Design Review Board Agenda

**CITY OF MILL CREEK
DESIGN REVIEW BOARD
APPLICATION PL2017-0010**

NAME OF PROJECT: La Petite Academy Freestanding Sign

PROPOSAL: Review of freestanding sign.

Attachment 1 – Existing and Proposed Monument Sign

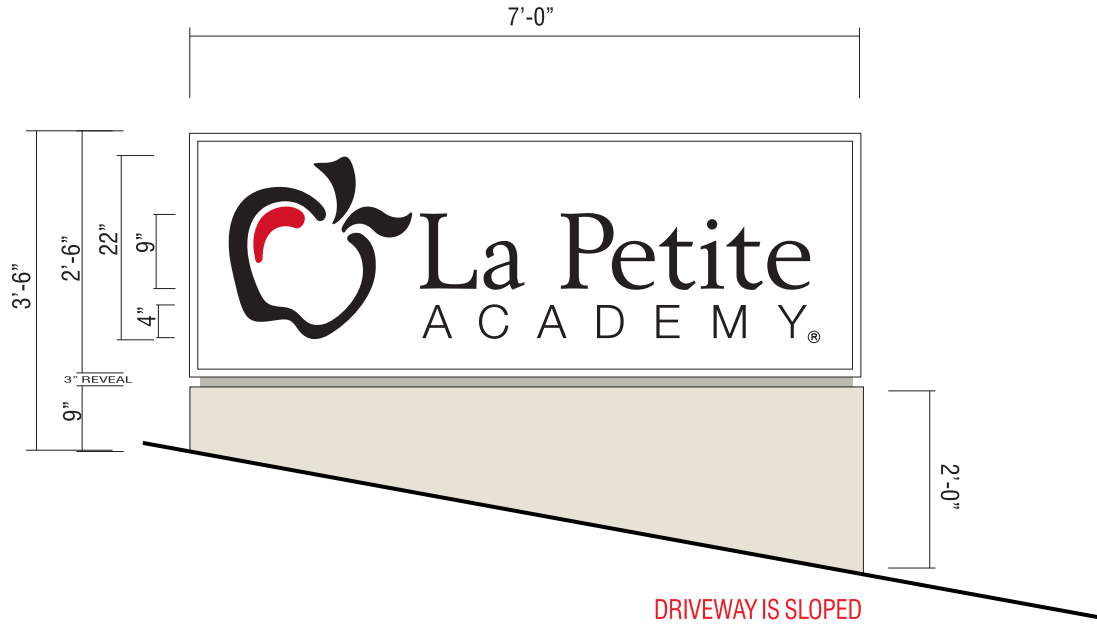
The total proposed sign area is 42 inches high, 12.8 square feet in area (double faced) to be visible in both directions from SR 527. The sign is proposed to be setback 5 feet from the SR 527 right-of-way. Due to the downward slope of the site the proposed supporting sign base is angled to provide a level base for the sign. The proposed sign is a white rectangle with black lettering with the corporate name “La Petite Academy” and apple logo in black and red. The color scheme is complementary to and coordinates with the proposed wall sign colors and proposed wall graphics, in accordance with MCMC Section 17.34.040.G.3.

Landscaping is not currently proposed for the landscape bed at the base of the sign. Therefore, staff is recommending a Condition of Approval requiring the applicant to top the areas around the sign with new mulch and plant a ground cover such as Kinnikinnick, which is tolerant of the drier conditions around the base of the sign.

1. The sign design, materials, and colors shall be as portrayed on the materials submitted with the application, except as may be modified by the conditions imposed by the Design Review Board.
2. The sign shall not be installed until a sign permit is issued by the Building Official.
3. Install mulch and a drought tolerant groundcover such as Kinnikinnick in the landscape bed around the base of the monument sign.
